APPEAL AGAINST REFUSAL OF PLANNING APPLICATION FOR THE ESTABLISHMENT OF
A NEW QUARRY ON LAND AT THE FORMER HATFIELD AERODROME

APPEAL REFERENCE: APP/M1900/W/24/3346607

Response from Ellenbrook Area Residents Association with regard to the new Public Access Strategy

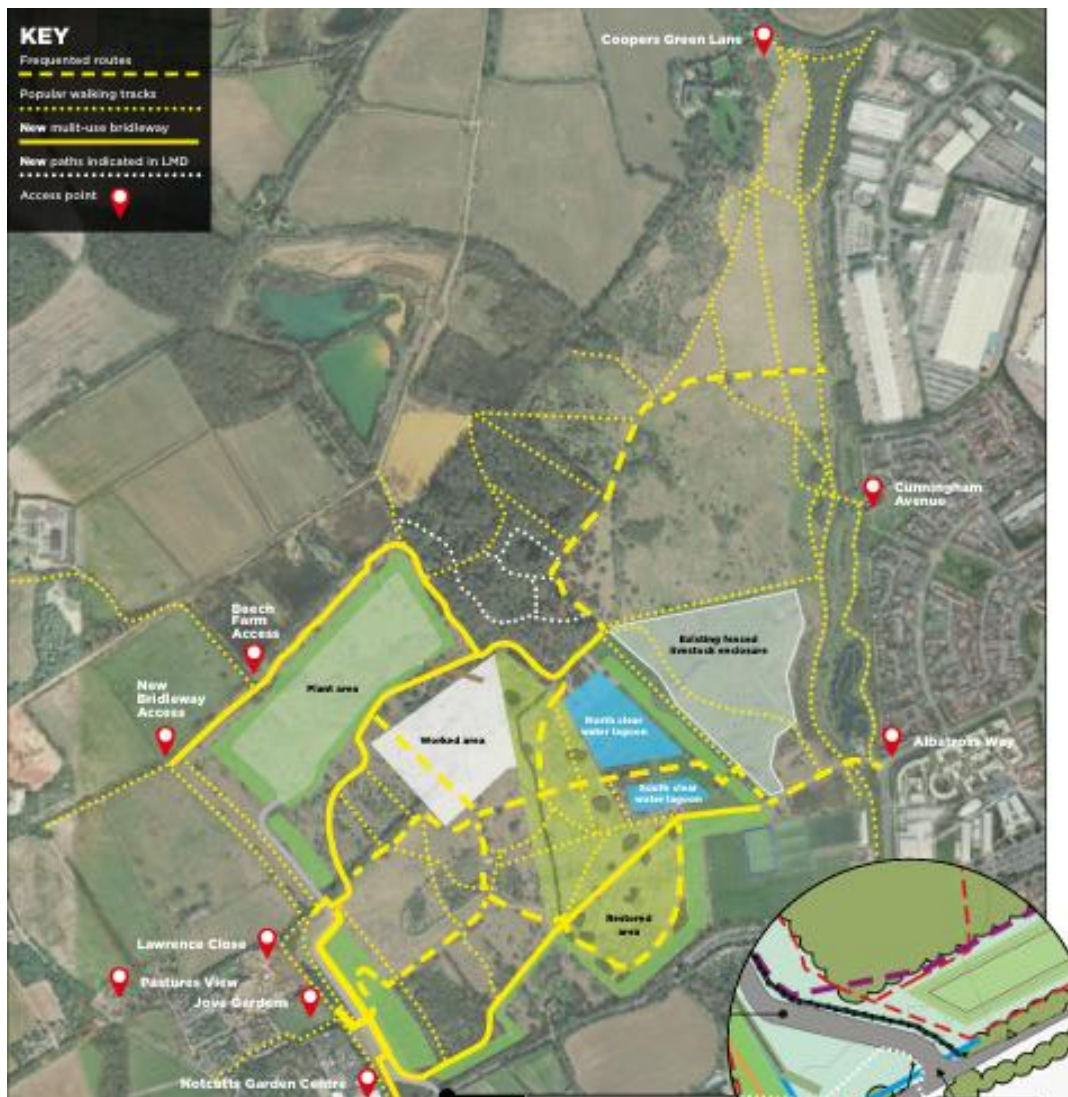
Brett have proposed a new pathway that will go through the lagoons. This is unsatisfactory for the following reasons

- There will only be a narrow grass pathway (approx. 3m) between the two lagoons, this is in contrast to the very wide pathway along the concrete taxiway currently enjoyed by most visitors to the park.
- In Winter months this pathway will be unusable as the grass surface will turn to mud, similar to the grass pathways on Ellenbrook Fields at the moment resulting in long diversions around the lagoons.
- This narrow pathway will be bordered by very deep lagoons with only a small fence separating the path from very deep water, creating a potential health and safety risk
